P.O.A.D.P. PLAN  
 for  
 BECKER RANCH ESTATES

**MDP#631 - MINOR MDP AMENDMENT**  
**TOTAL AREA 125.7 ACRES**

Re: Becker Ranch

POADP # 631

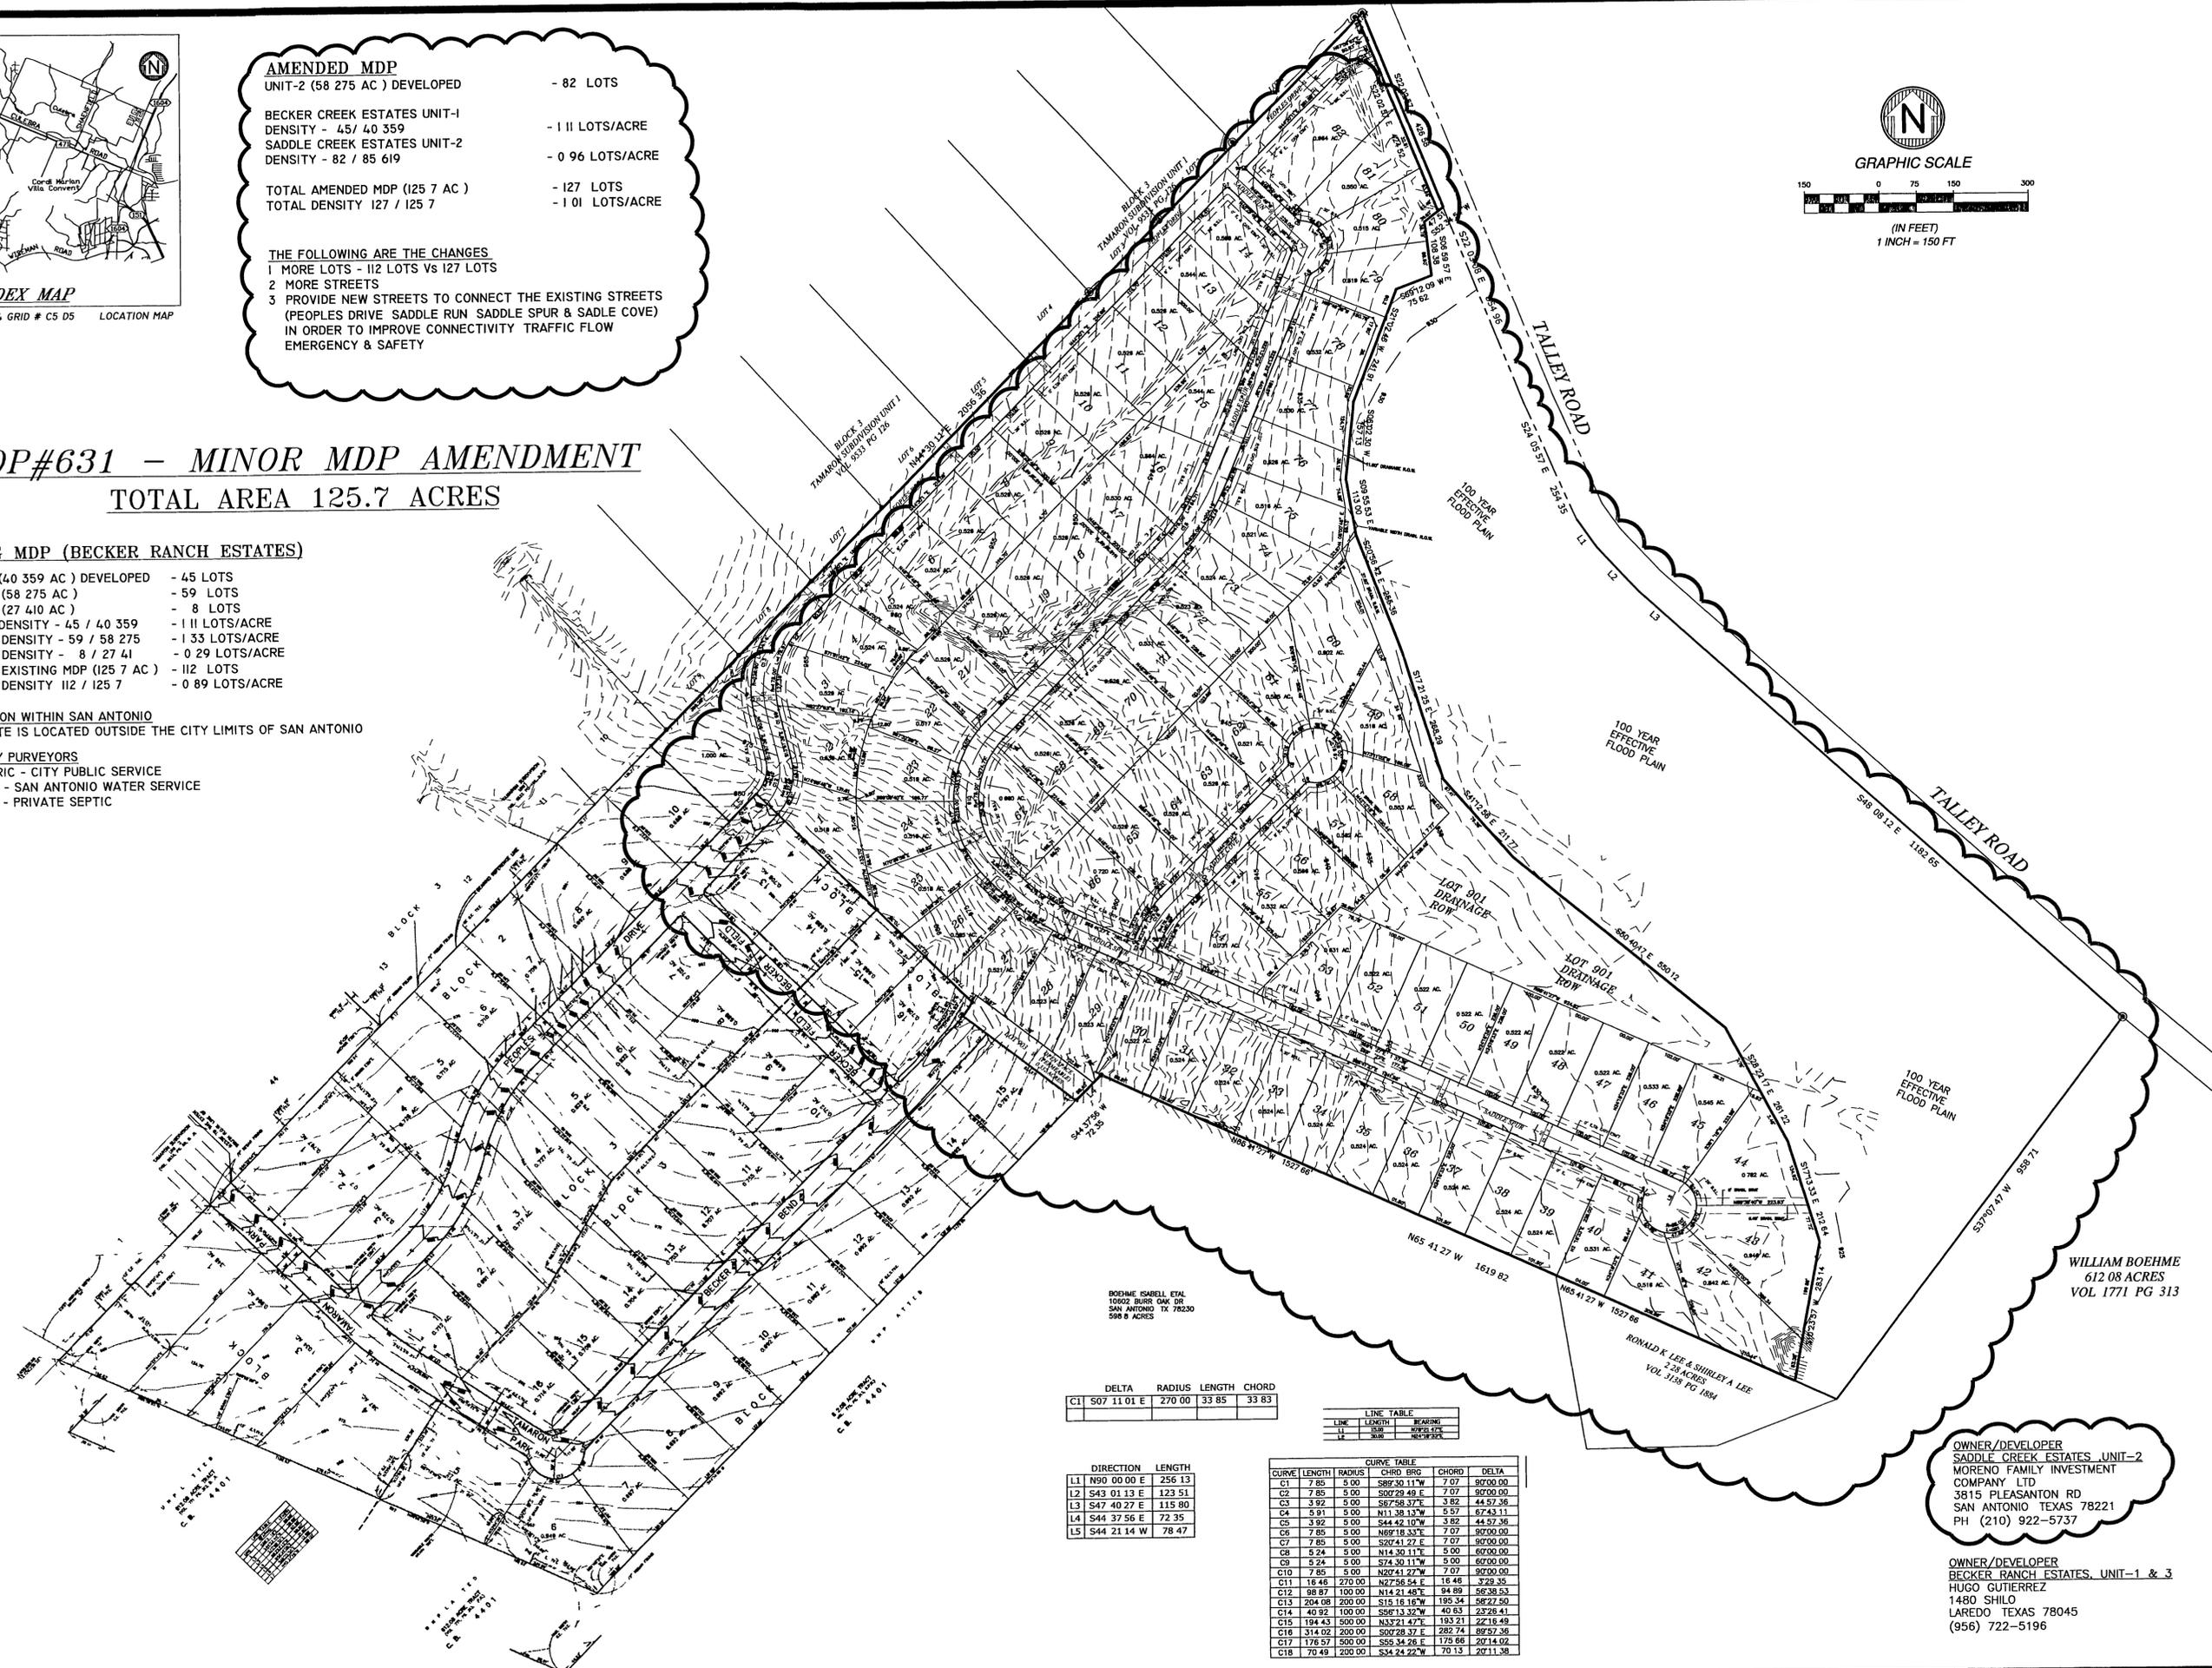
THE FOLLOWING ARE THE CHANGES  
 1 MORE LOTS - 112 LOTS VS 127 LOTS  
 2 MORE STREETS  
 3 PROVIDE NEW STREETS TO CONNECT THE EXISTING STREETS (PEOPLES DRIVE SADDLE RUN SADDLE SPUR & SADDLE COVE) IN ORDER TO IMPROVE CONNECTIVITY TRAFFIC FLOW EMERGENCY & SAFETY
